Access Compliance Report

Public Rights-of-Way

Intersection ID: N/A	Main Street: SMITH_RD	Cross Street: CANTERBURY_CASTLE_DR	Location: SW
ADA ID: 22D4EA1587C7	Ramp Type: Perp	Initial Pass/Fail: Fail	Overall Compliance: No
			Severity Score: 33.75

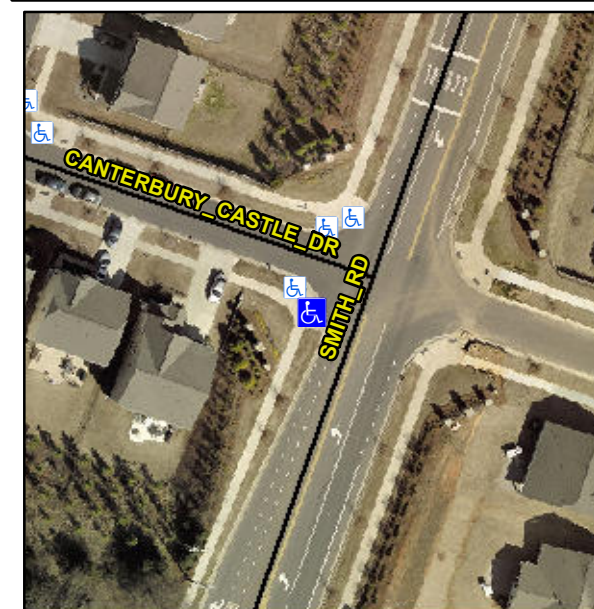
Not Found, R304.5.1, R304.2.2, R304.5.3

Compliance	Description	Data	Compliance	Description	Data
N/A	Ramp Length (in)	96.0	No	Ramp Slope (%)	9.3
No	Ramp Width (in)	47.0	No	Ramp XSlope (%)	6.8
N/A	Flare Type LT	N/A	N/A	Flare Type RT	N/A
N/A	Flare Slope LT (%)	N/A	N/A	Flare Slope RT (%)	N/A
N/A	Flare Traversable LT?	N/A	N/A	Flare Traversable RT?	N/A
N/A	Landing Length (in)	N/A	N/A	DWS Provided?	N/A
N/A	Landing Width (in)	N/A	N/A	DWS Contrast?	N/A
N/A	Landing Slope (%)	N/A	N/A	DWS Length (in)	N/A
N/A	Landing X Slope (%)	N/A	N/A	DWS Full Width?	N/A
N/A	Landing Curb? (Y/N)	N/A	N/A	DWS Offset (in)	N/A
N/A	Shared Landing?	N/A			
N/A	Gutter Ponding?	N/A	N/A	Gutter Slope (%)	N/A
N/A	Gutter Lip Ht (in)	N/A	N/A	Gutter X Slope (%)	N/A
N/A	Painted X Walk1?	No	N/A	Painted X Walk2?	N/A
	X Walk 1 Direction	To SE		X Walk 2 Direction	N/A
N/A	X Walk 1 Width (in)	N/A	N/A	X Walk 2 Width (in)	N/A
	X Walk 1 Slope (%)	5.1		X Walk 2 Slope (%)	N/A
	X Walk 1 X Slope (%)	7.2		X Walk 2 X Slope (%)	N/A

Remove & Replace Entire Ramp.
